**STATE SIGNIFICANT DEVELOPMENT:  
Section 96(2) Modification**

**Site 68, Sydney Olympic Park**

**SSD 6603 MOD1**

Secretary's Environmental Assessment Report  
Section 96(2) of the  
*Environmental Planning and Assessment Act 1979*

Figure 4: Approved (left) and proposed (right) western elevation, additional levels circled with a red-dashed line (Base source: applicant's RtS)

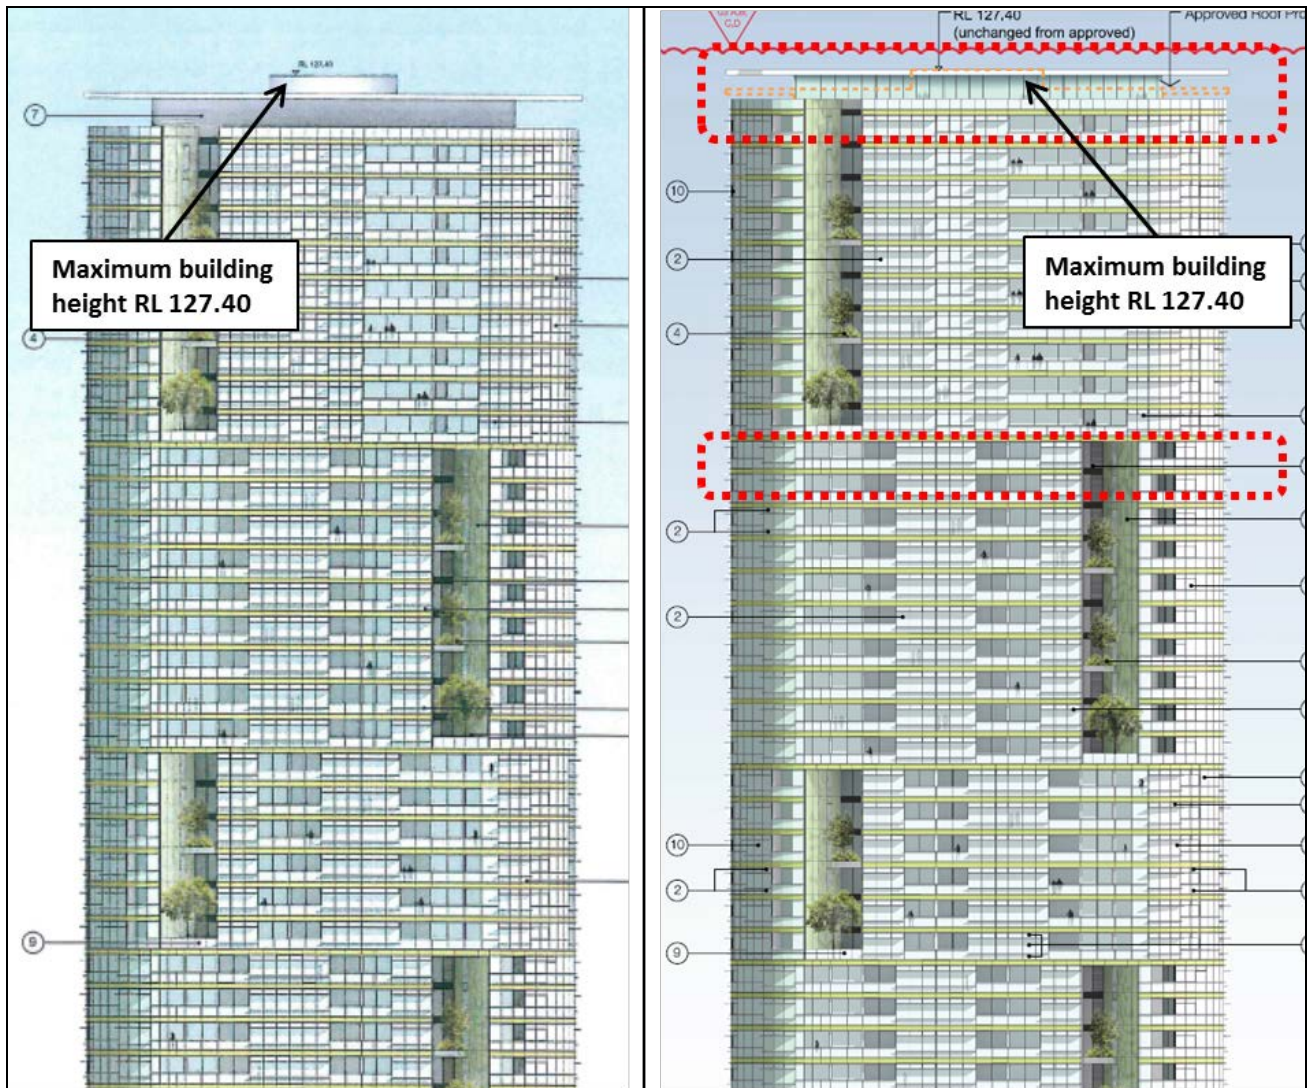
The Department notes that due to the proposed minor reductions to the floor to floor heights and the ground floor level, in conjunction with the rationalisation of rooftop plant, the proposed additional residential levels have been accommodated within the overall height of the building (i.e. not extending above the height of the approved plant level) as shown at **Figure 4**.

In support of the proposed insertion of two additional residential levels, the applicant contends that the variation to the development standards is reasonable as the modified building would maintain consistency with setback controls, be consistent with the objectives of the B4 Mixed Use zone, be no taller than the maximum height of the approved plant level (RL 127.4), not have any adverse amenity impacts and continue to exhibit design excellence.

- have been discreetly integrated into the overall design of the building and would not interrupt the unique architectural identity, articulated or modulation of the building facades;
- have been incorporated into the overall maximum height (to rooftop plant) and therefore are unlikely to be discernible; and
- would not otherwise alter the overall design or appearance of the building.

Figure 5: Approved (left) and proposed (right) ground floor layout (Base source: applicant's application)

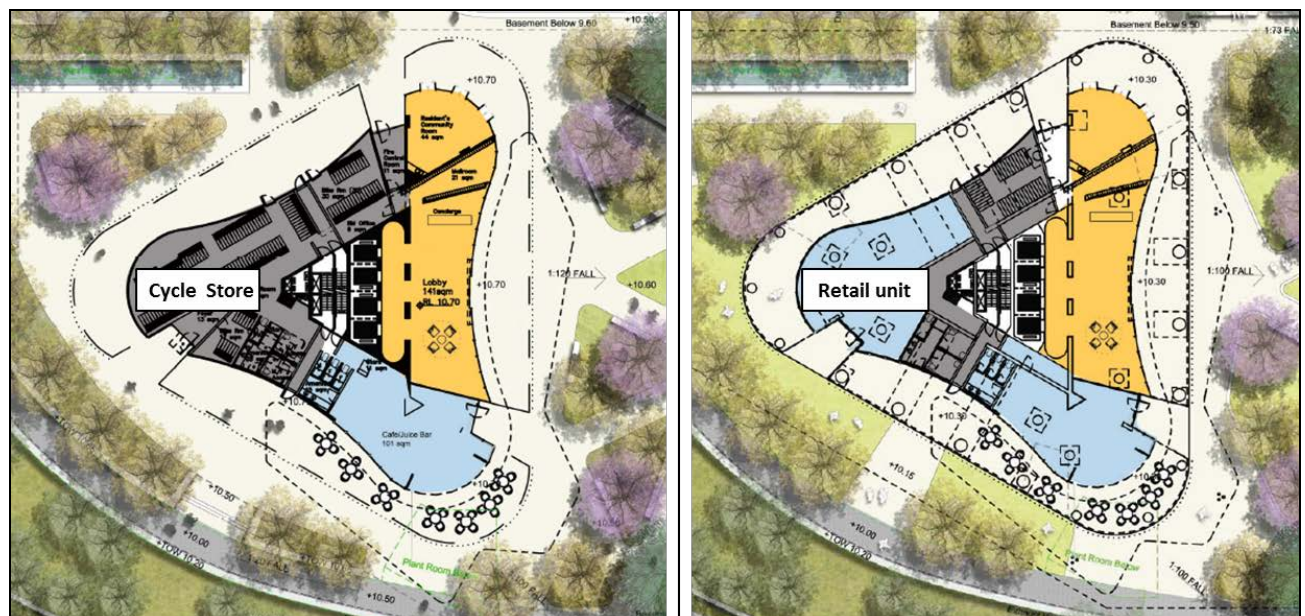
The proposal includes an increase of 30 bicycle parking spaces commensurate with the increase in GFA and residential apartments. In addition, the proposal seeks approval for the conversion of part of the ground floor bicycle store into a retail unit (refer to **Figure 5**) and provision of 98 visitor bicycle spaces within the public domain.

The Department considers that the above amendments to bicycle storage are acceptable as the provision of visitor spaces throughout the public domain will encourage the use of bicycles to and from the development. In addition the provision of a new retail unit at ground floor level will provide for additional ground floor level activation.

The Department recommends that condition A12 be updated to reflect the amendments to bicycle parking spaces.

**Figure 6: Part elevation plans (above Level 22) showing the approved (left) and proposed (right) building heights and RLs (Base source: applicant's application)**

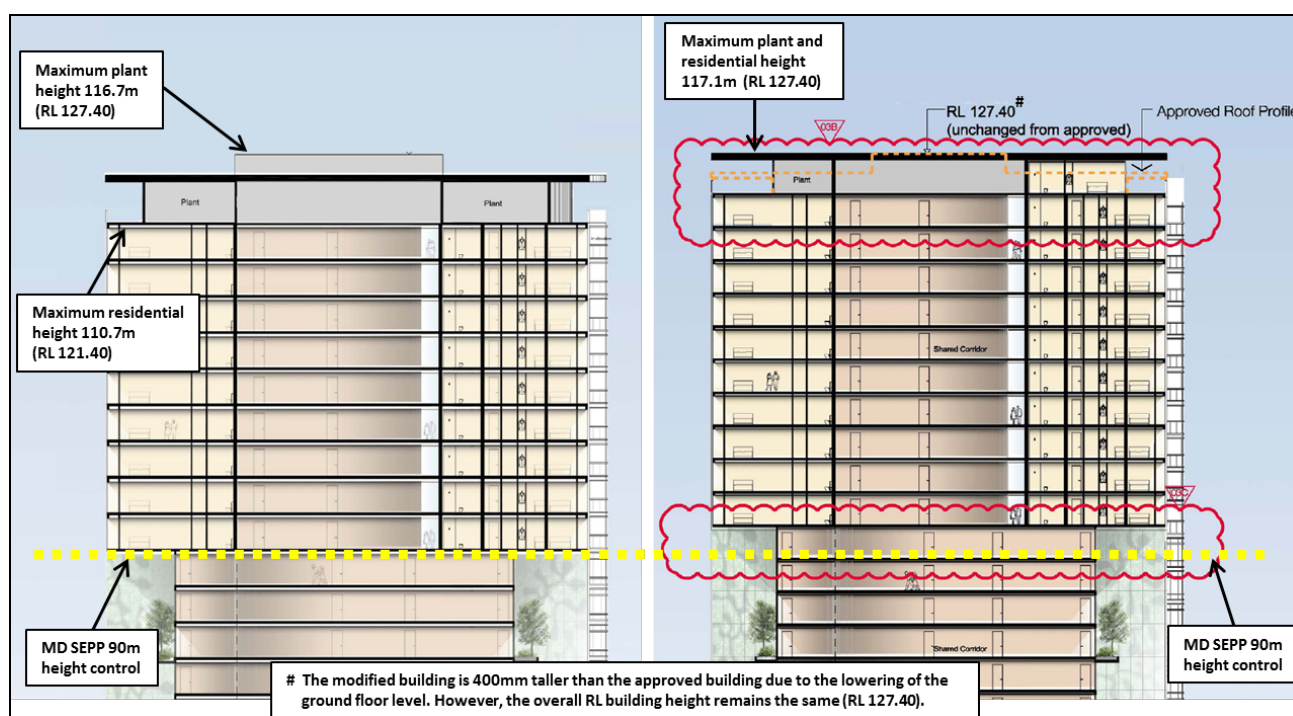
- increase the maximum building height to the top of the residential levels by 6.4 metres (to 117.1 metres, RL 127.4), being no taller than the approved plant room height, as shown at **Figure 6**; and
- increase the GFA by 2,468m<sup>2</sup> (to 35,635m<sup>2</sup>) and corresponding increase in FSR of 0.13:1 (to 2.5:1).

The Department notes that the approved building has an overall maximum height of 116.7 metres to the top of rooftop plant, which is not included in the height for purposes of compliance with the development standard. The proposal seeks to rationalise plant and utilise this space for residential uses increasing the height of the uppermost residential level to 117.1 metres, while retaining the approved overall maximum height of RL 127.4. The proposal will therefore not result in any change to the actual height of the building and will therefore not result in any material impacts to the visual bulk of the building and its relationship with emerging high rise dense urban character of the Parkview Precinct within the *SOP Master Plan 2030*.

The Department therefore supports the proposed variation of the development standards. The variation of the height and FSR development standards do not raise any matters of significance for State or regional environmental planning and the public benefit of the proposal would not be compromised.
